TCAS in TA ONLY: intruders shown as TAs

While resolution advisories are inhibited, an intruder that would be an RA is shown and announced as a traffic advisory; the TA ONLY message is centred on the A32NX ND as in the FCOM

Aircraft	A32NX and A380X
Where to find it	ND traffic display; TCAS mode on the A32NX TCAS panel / A380X SURV CONTROLS
PR branch	pr/07-tcas-ta-only-intruder-level (independent)
Status	Tested in the sim by the user: OK (2026-09-29).
Pictures	Captain NDs in the local browser harness, running the builds installed in the sim; the symbol legend is a drawing (the harness has no traffic).

Figure 2. A32NX: TA ONLY, centred at the bottom of the ND (A320 FCOM DSC-34-SURV-60-20 figure).

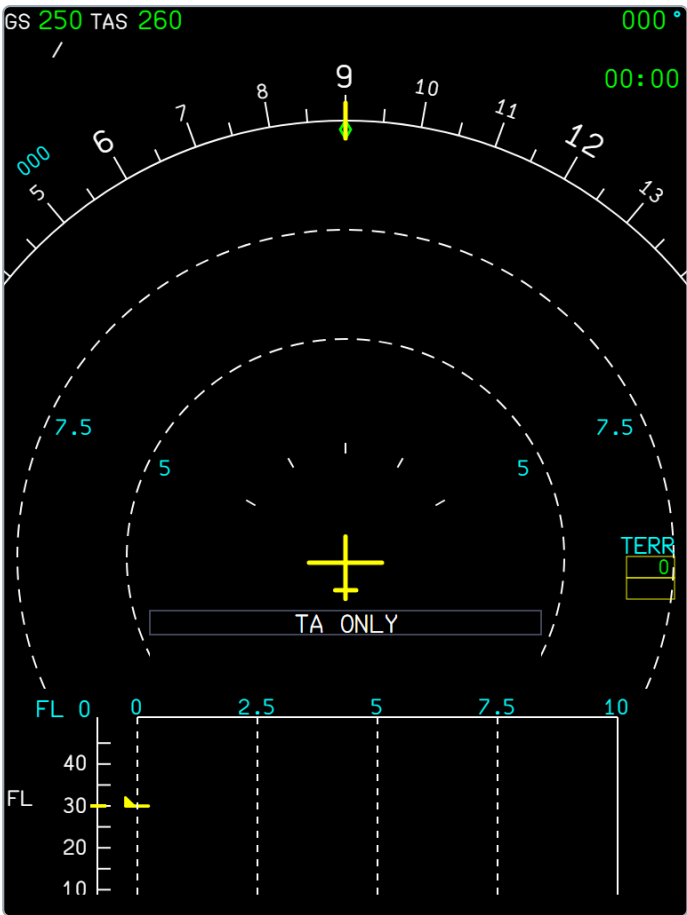
With every RA inhibited (TA ONLY selected, or below 1000 ft radio altitude), the TCAS kept classifying an intruder that met the RA criteria as an RA. The ND drew it as a red RA square, and since it was not a TA, there was no "TRAFFIC, TRAFFIC" and no TA state. A real TCAS in TA ONLY shows it as an amber TA with the TA aural. The classification is now capped at TA while all RAs are inhibited.

Situation	What you should see
TA ONLY selected, intruder meeting the RA criteria	Amber TA circle and "TRAFFIC, TRAFFIC" (before: red RA square, no aural).
Below 1000 ft radio altitude (all RAs inhibited)	Same: TAs only, TA ONLY on the ND.
Partial inhibits (no CLIMB / DESCEND / INCREASE DESCENT RA)	Unchanged: RAs are still issued.
An RA already running when the inhibit starts	It runs to its own end.
